REQUEST:	Request by Peters Construction for a Site Plan Amendment in the "C-2, C-Z" Commercial Conditional Zoning District for a new funeral home and crematorium in the existing building plus a 10,175 square foot addition located at 4140 Kimball Avenue.
APPLICANT(S):	Peters Construction, 901 Black Hawk Road, Waterloo, Iowa 50701
GENERAL DESCRIPTION:	The applicant is requesting a new funeral home in an existing building with a 10,175 square foot addition.
SURROUNDING LAND USES AND IMPACT ON NEIGHBORHOOD:	The request for a site plan amendment would not appear to have a negative impact upon the surrounding area as it would appear to be compatible with other commercial development in the area.
VEHICULAR & PEDESTRIAN TRAFFIC CONDITIONS:	The proposed site plan amendment would not appear to have a negative impact upon vehicular or pedestrian traffic conditions in the area. The site is served by Kimball Avenue, which is a Minor Arterial.

City of Waterloo Planning, Programming and Zoning Commission
September 1, 2020

4140 Kimball Avenue Site Plan Amendment Peters Construction

RE: 4140 Kimball Ave
Site Plan Amendment Application
Other Pertinent Information

CIVIL SITE PLAN – PRELIMINARY

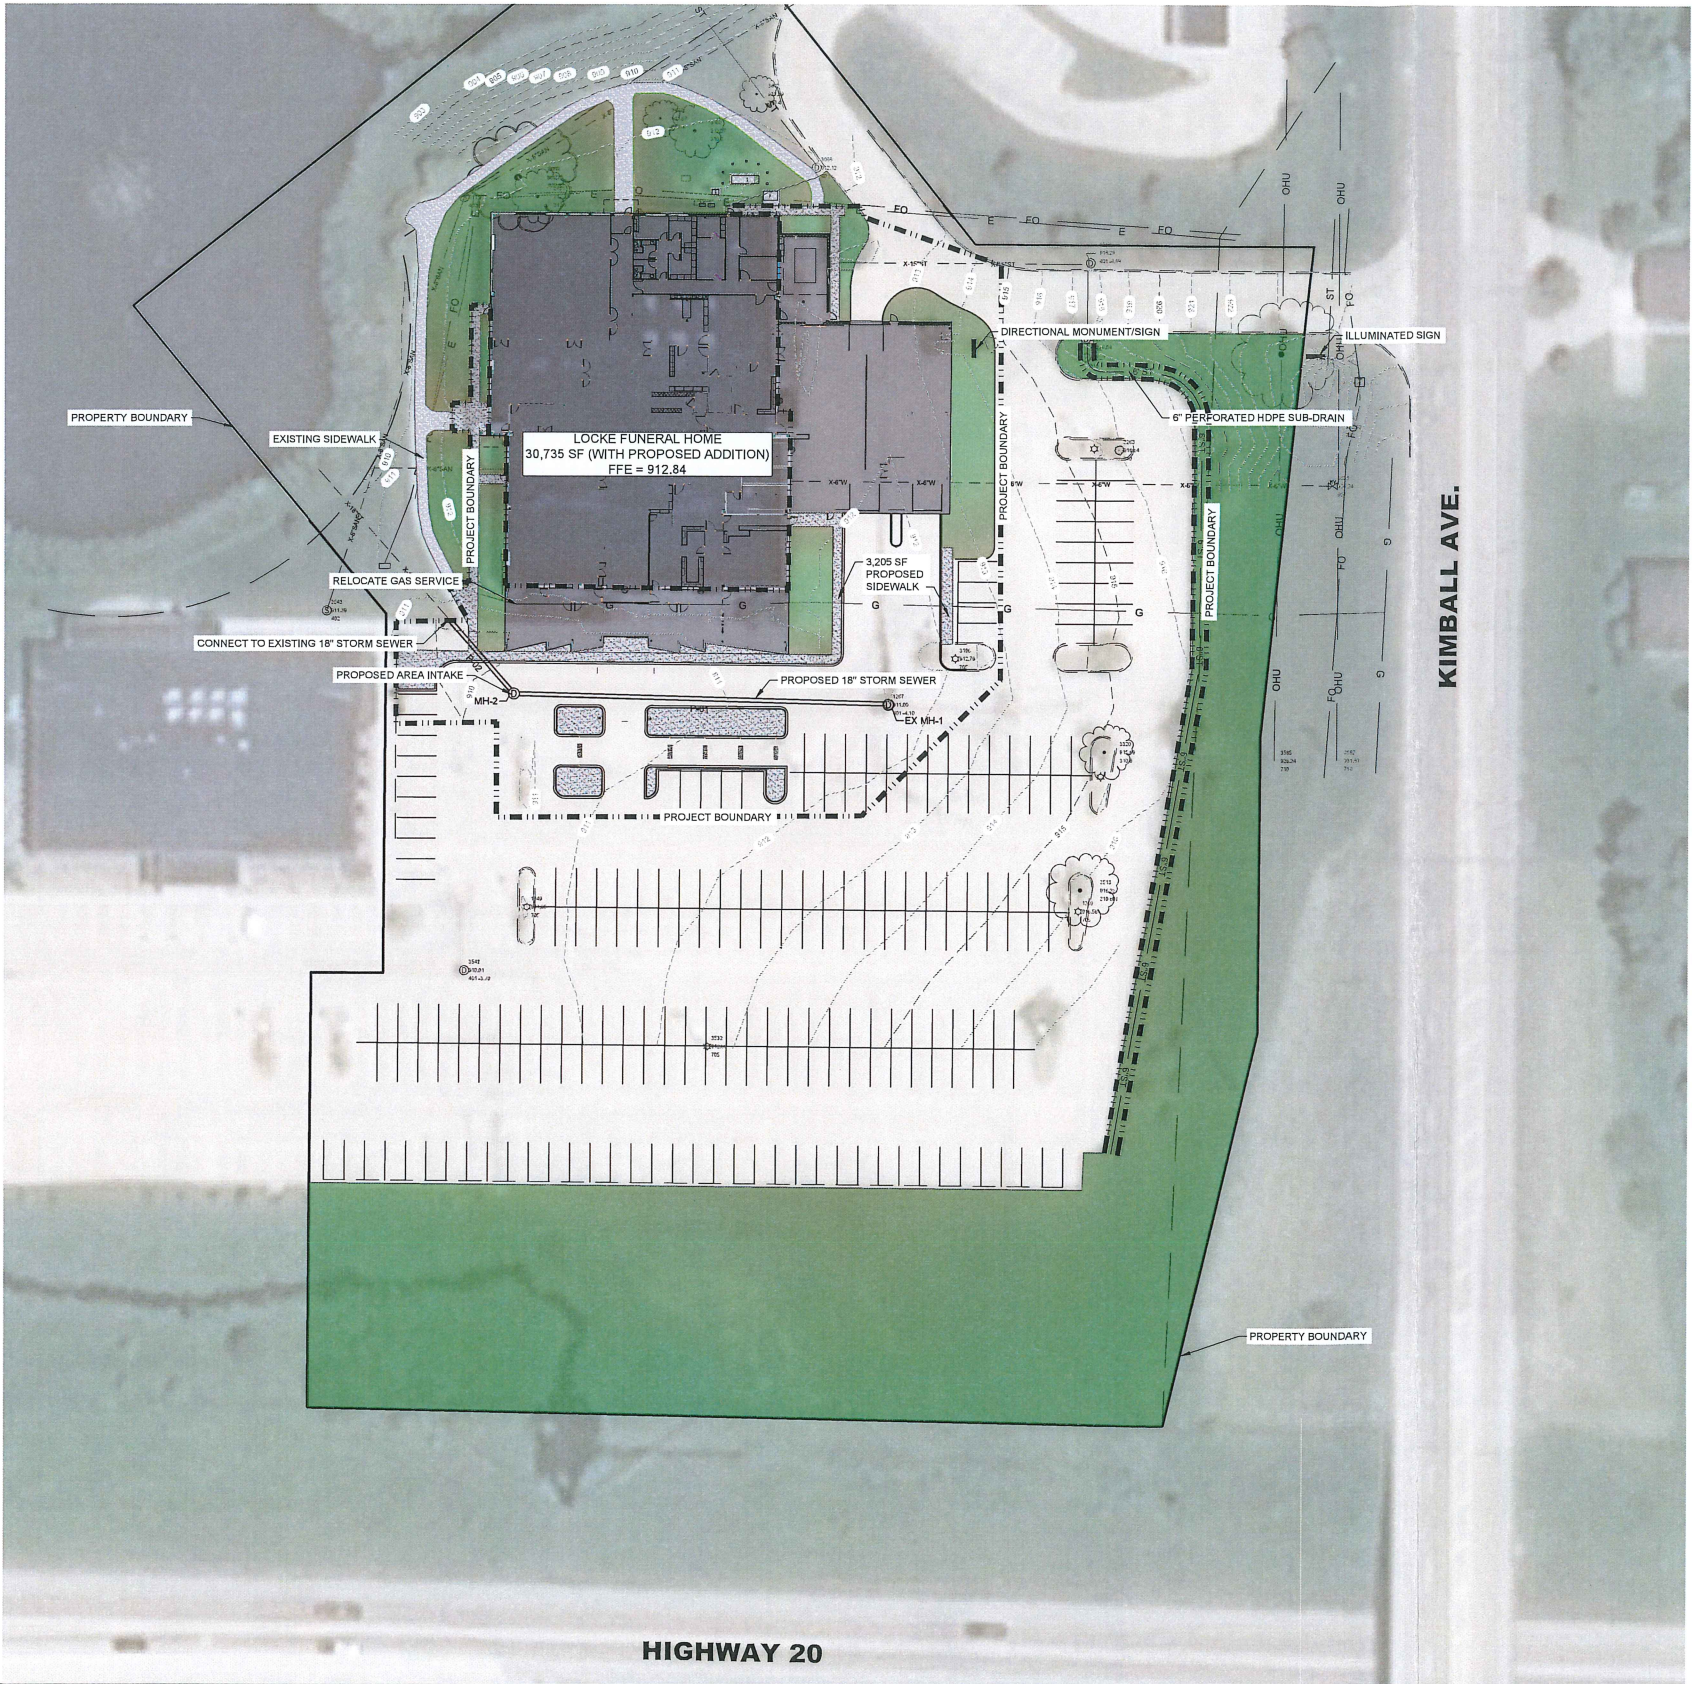
The applicants are also proposing to have an illuminated sign along Kimball Avenue however, were currently shown the sign would be in city right-of-way and would require an encroachment agreement, however there are several overhead utilities in close proximity to the proposed sign. A separate application would be required to review any requested encroachment agreement. There are utilities on both sides of the proposed sign and if approved by encroachment agreement and at some point the utilities companies need to remove the sign in order to access those utilities it would be at the risk and expense of the property owner. Staff will discuss this further with the applicant.

Knutson noted during tech that if the applicants are only using their existing hard surfacing for the addition which the site plan shows then they will not need to change their detention.

1. That the final site plan meets all applicable city codes, regulations, etc. including, but not limited to, parking, landscaping, screening, drainage, etc.
